BUILDING COMPLETION REPORT

NOTICE OF COMPLETION UNDER SECTION 187 (I) OF THE
CITY OF KARACHI MUNICIPAL ACT, 1933

FINAL.
PLAN SHOWING PROPOSED
ADD: & ALTERATION IN BUNGALOW
ON PLOT NO 173 J.M.I.
JAMSHED QUARTER.
SCALE = 8"=1'

With reference to your application dated 24-7-39,
with a plan for the proposed buildings/additions and alterations on plot
No. 64 Survey Sheet No. J.M.1, Jamshed Quarter,
I have to request you to comply with the following requirements—

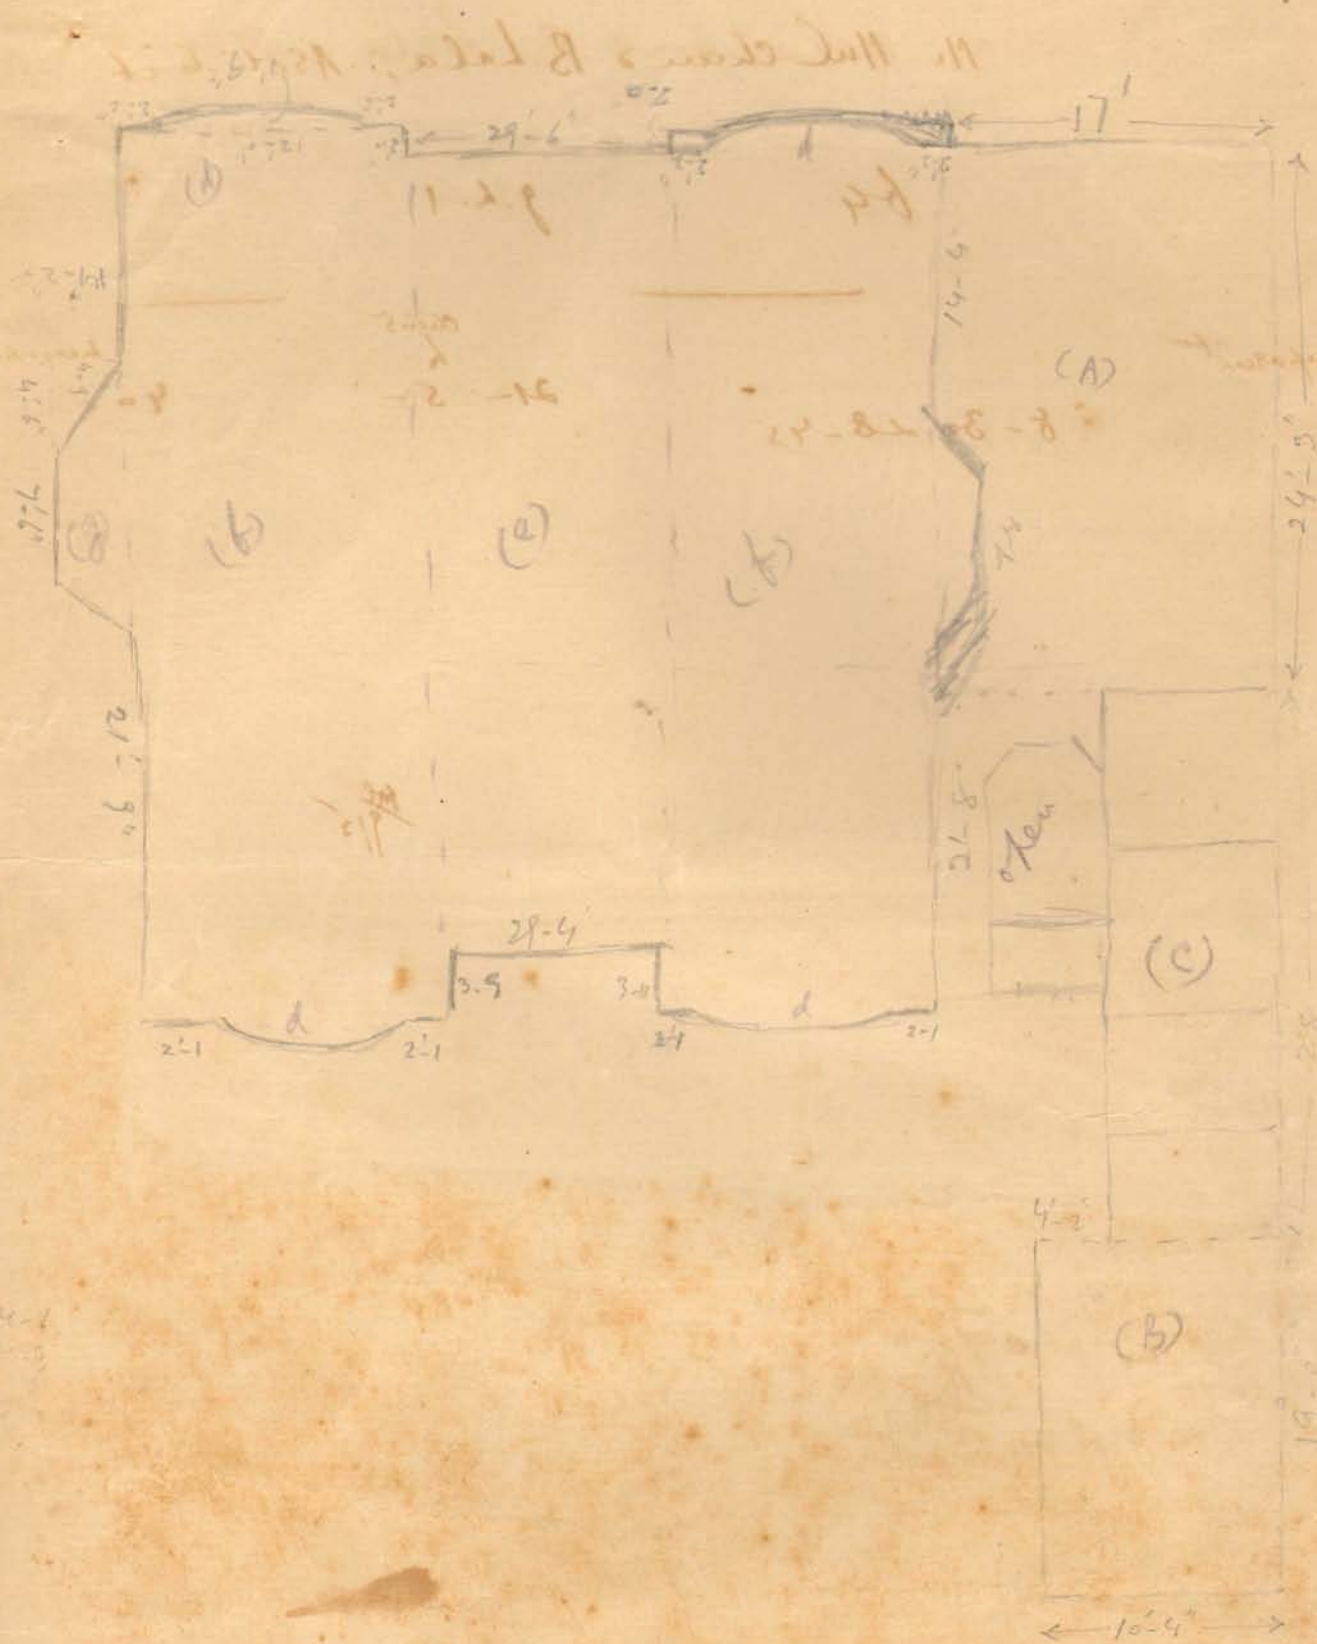
The existing ~~area~~ built-up area, as per approved plan, was 422.20 sq. yds. The area now built-up is 61.65 sq. yds. ^{inclusive of plaster}. The total built-up area thus comes to 483.85 sq. yds, whereas the allowable limit is 483 sq. yds. If plaster is excluded the built-up area would be within limits.
